HIGHLAND CITY DEVELOPMENT ADMINISTRATION BOARD AGENDA

DEVELOPMENT ADMINISTRATION BOARD AGENDA REPORT ITEM #1

DATE: October 10, 2024
TO: Development Administration Board
FROM: Rob Patterson, City Attorney / Planning & Zoning Administrator
SUBJECT: **Final Plat Approval:** Foxwood Estates
TYPE: **LAND USE (ADMINISTRATIVE)**

ATTACHMENT 6

PP02

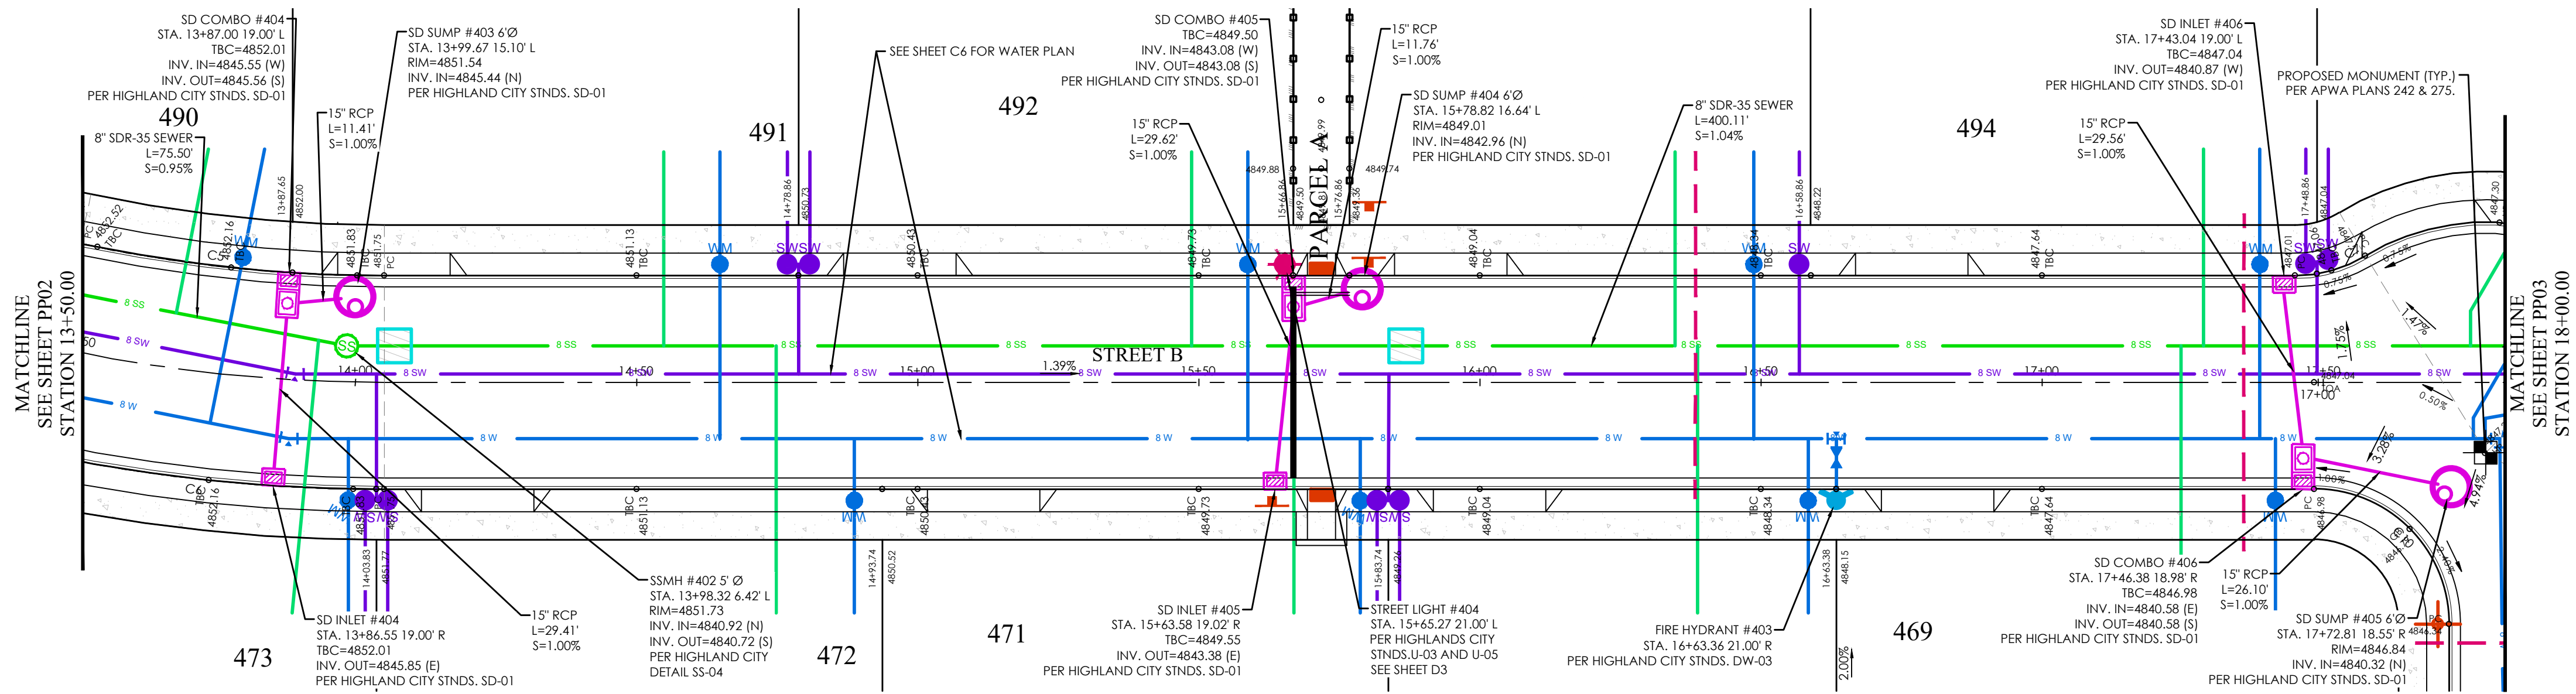
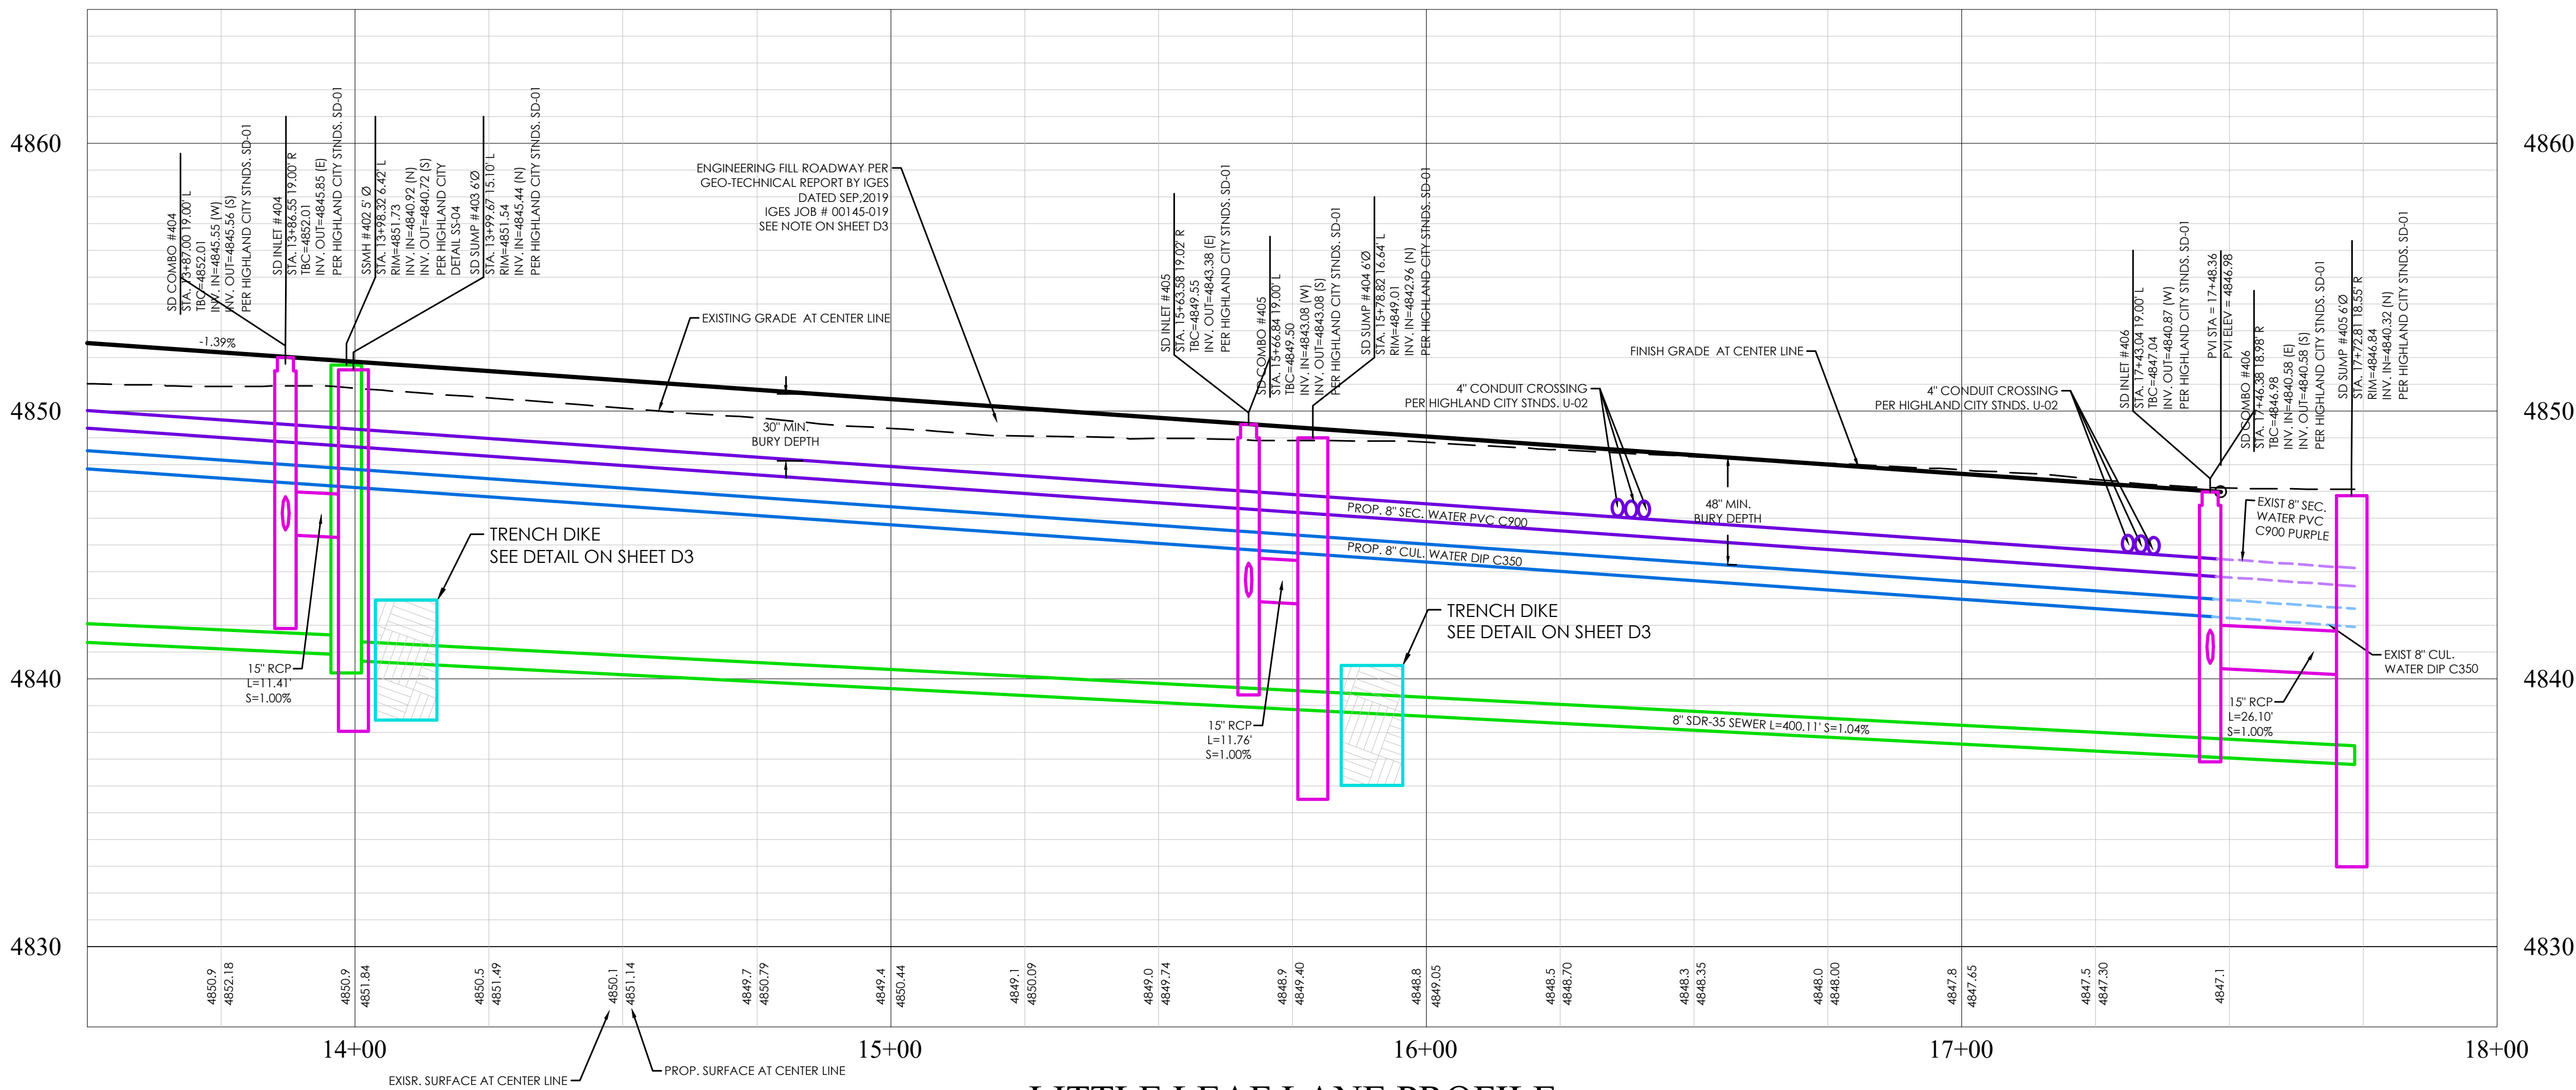
4. Green Ash Lane/Street B, Sheets PP01, PP02, PP03: Remove "Street B" from match lines and from plan views.
5. Crimson Oak Lane, Street Monument, Sheet PP04: Please provide reasoning for the location of the street monument. It does not mark the intersection of the two streets.
